107 HIGH STREET, LINDFIELD, HAYWARDS HEATH, RH16 2HR

**PART VII | PROPOSED REGULARISATION
OF SCHEME**

The proposed scheme hereunder assessed is a variation of the scheme approved under DM/22/3694 and DM/22/3695, combining elements of the scheme as implemented and other elements, as yet not implemented.

COMPARISON - NORTH ELEVATION. 1:50@A3

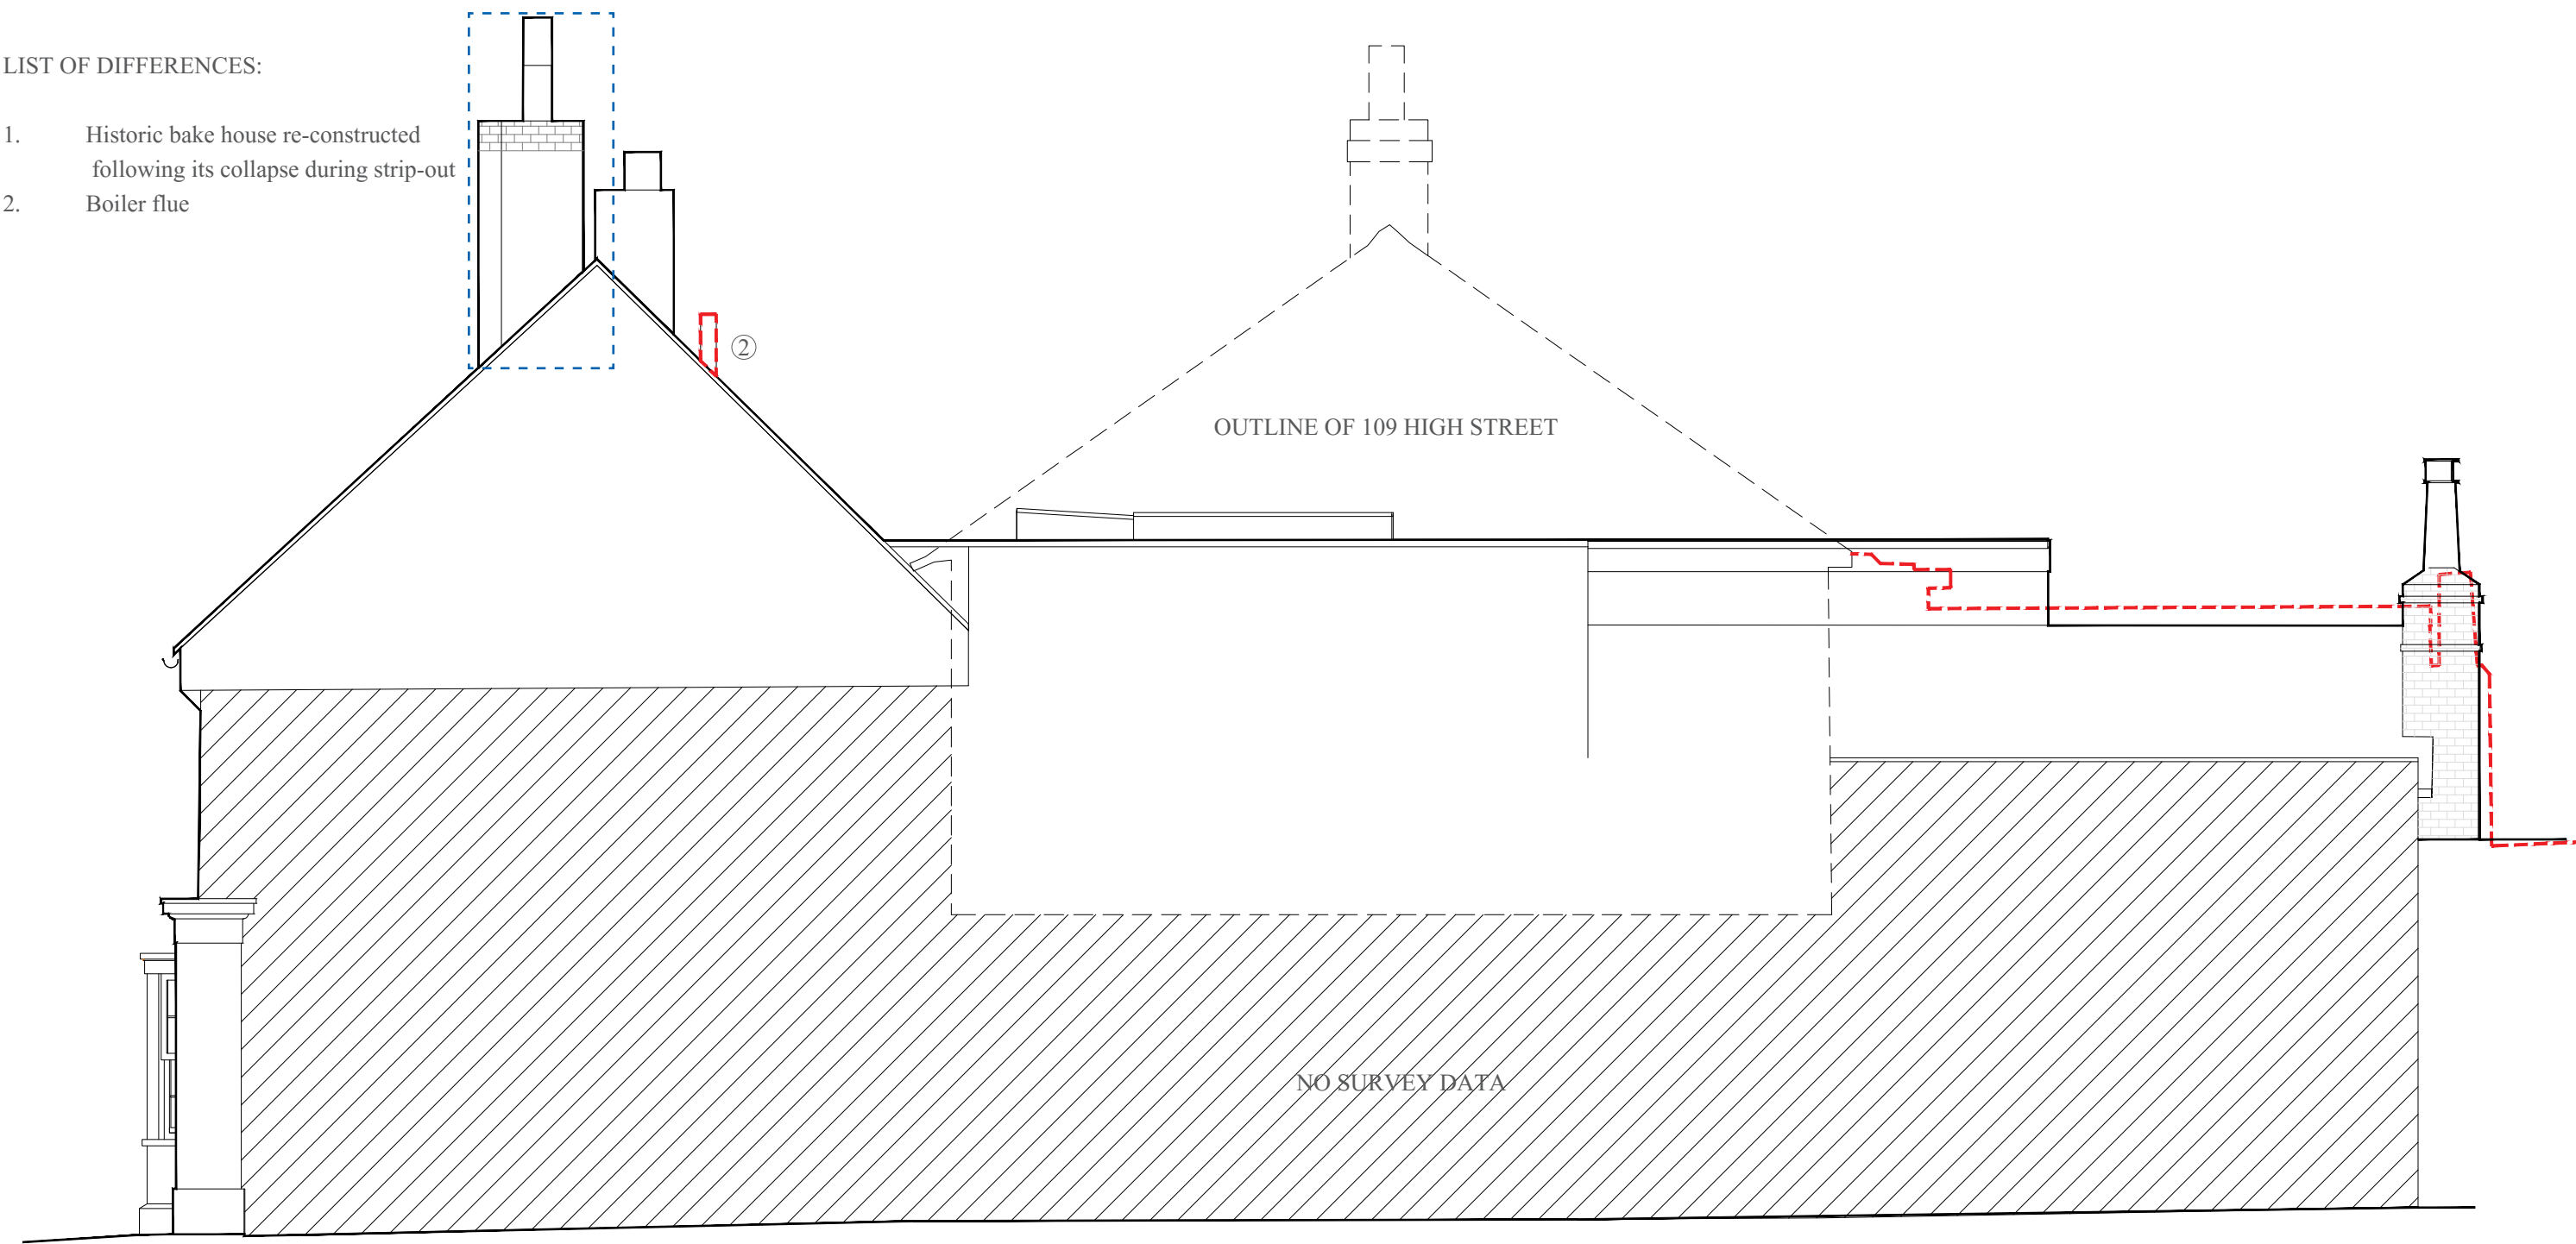
1. Historic bake house re-constructed following its collapse during strip-out
2. Boiler flue

COMPARISON - SECTIONAL ELEVATION AA REV A. 1:50@A3

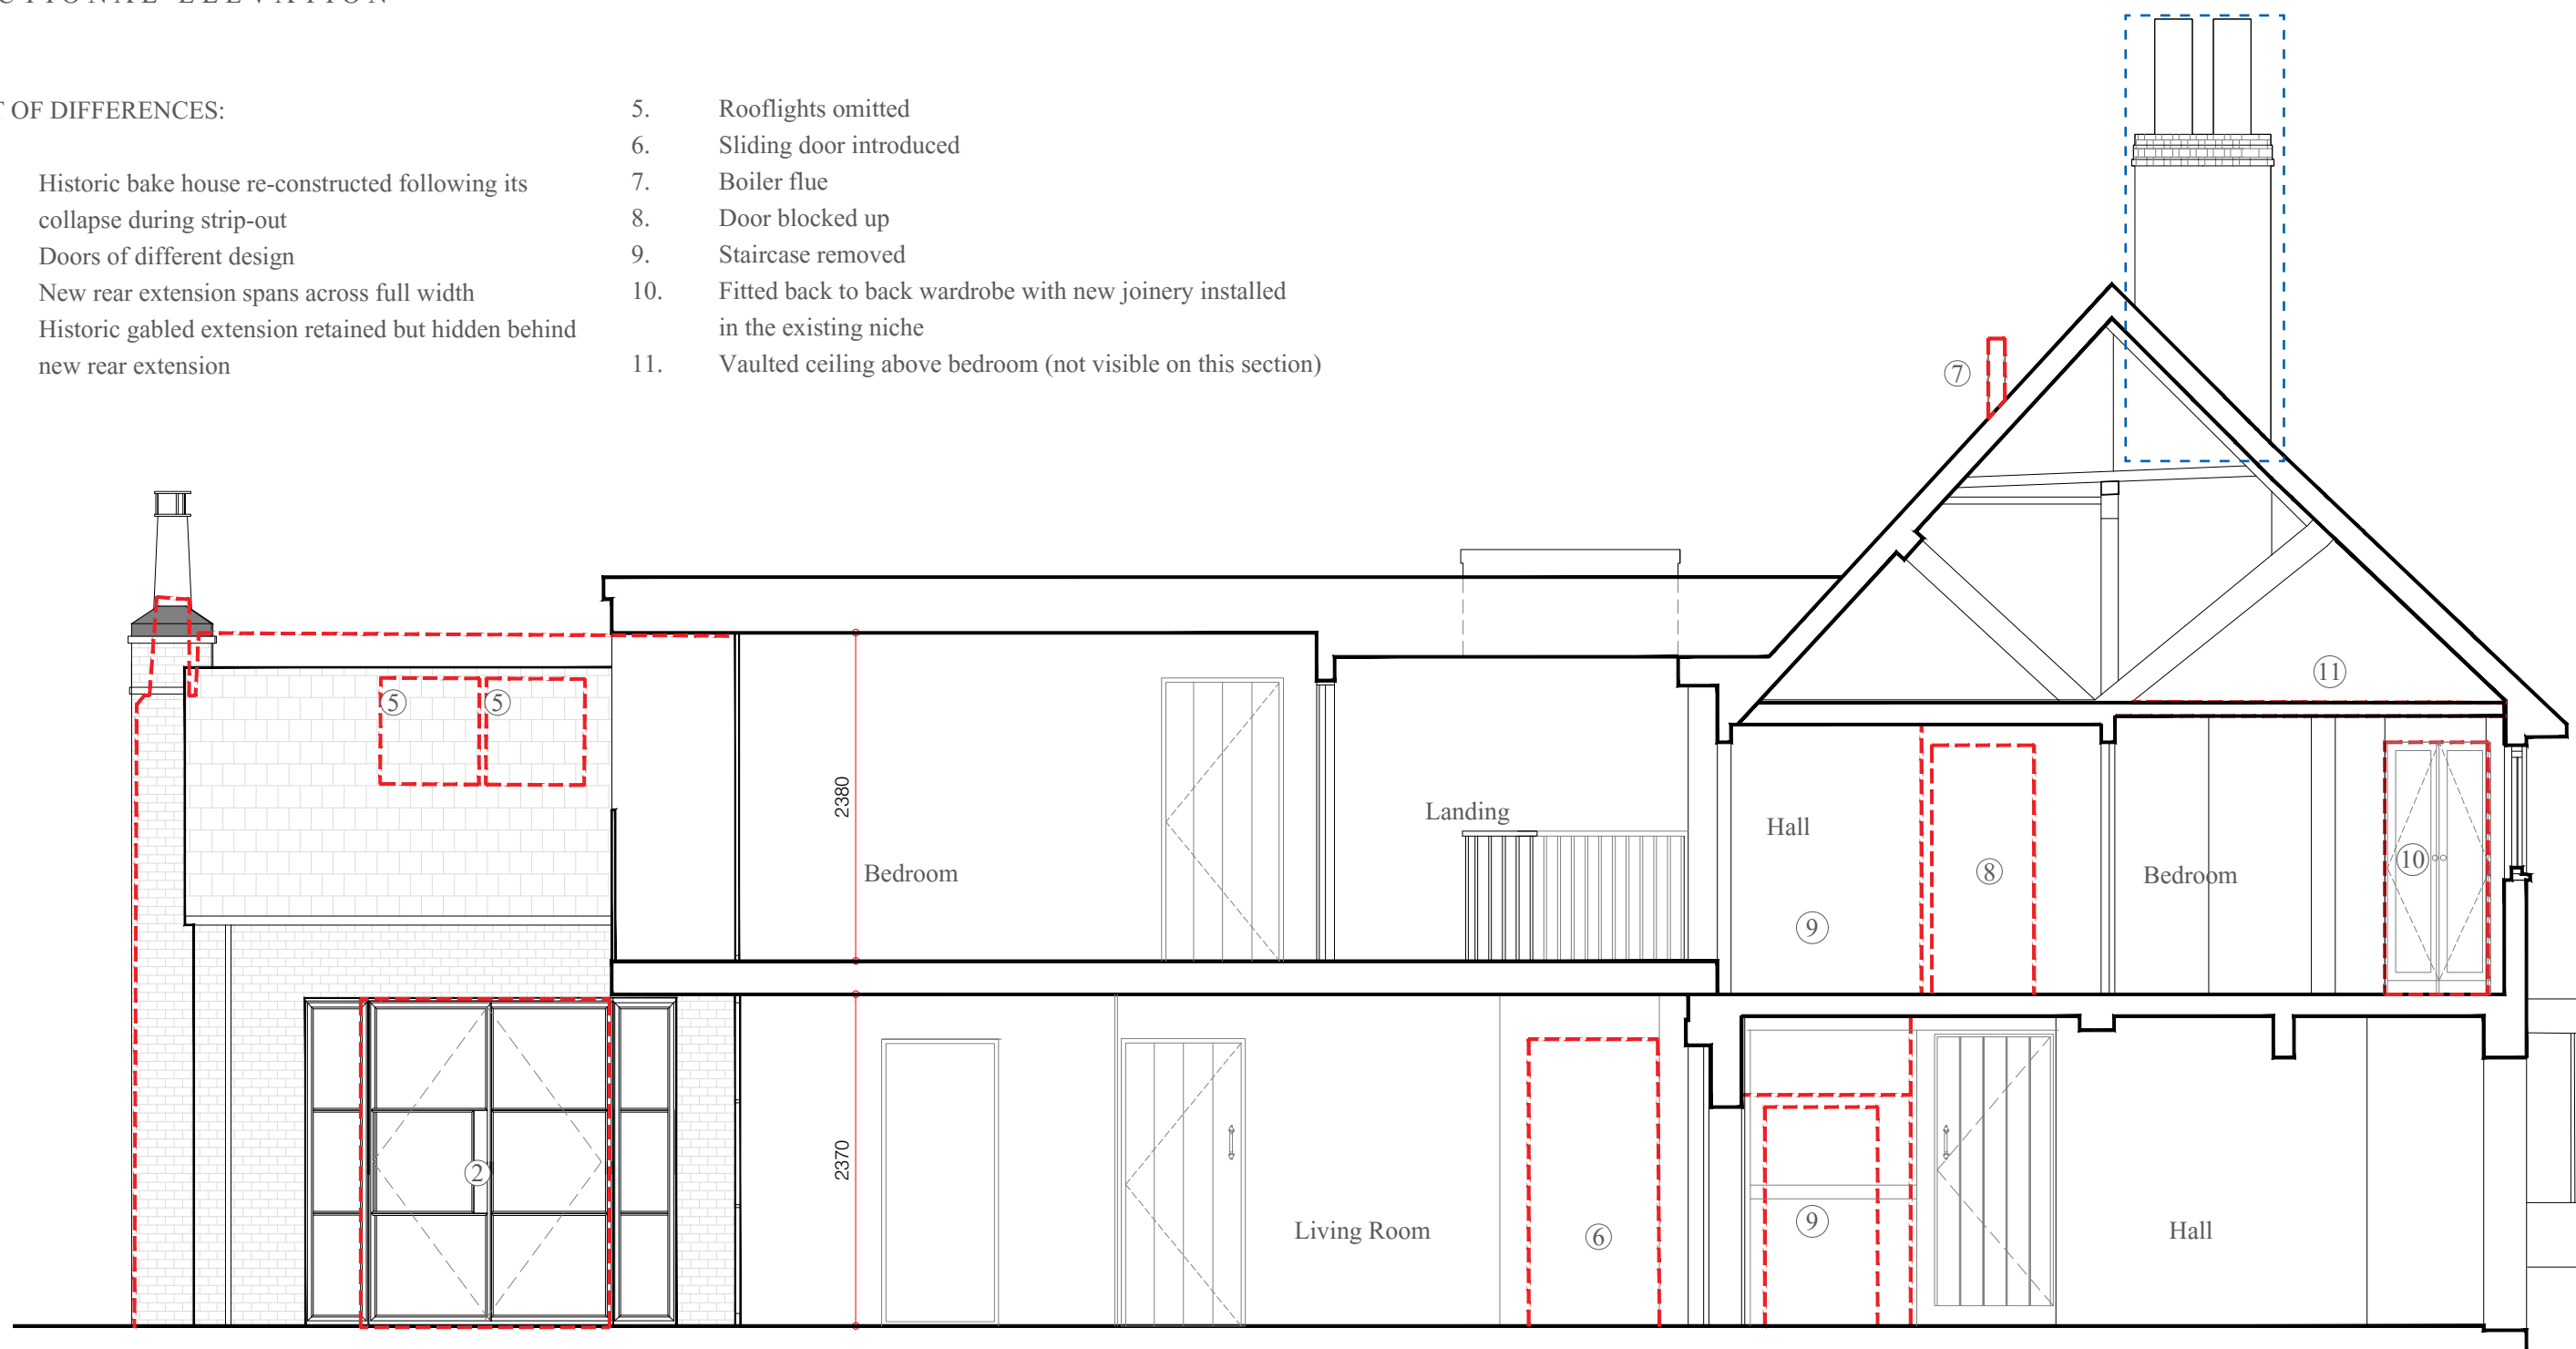
| 1. | Historic bake house re-constructed following its collapse during strip-out | 5. | Rooflights omitted |
| 2. | Doors of different design | 6. | Sliding door introduced |
| 3. | New rear extension spans across full width | 7. | Boiler flue |
| 4. | Historic gabled extension retained but hidden behind new rear extension | 8. | Door blocked up |
| | | 9. | Staircase removed |
| | | 10. | Fitted back to back wardrobe with new joinery installed in the existing niche |
| | | 11. | Vaulted ceiling above bedroom (not visible on this section) |
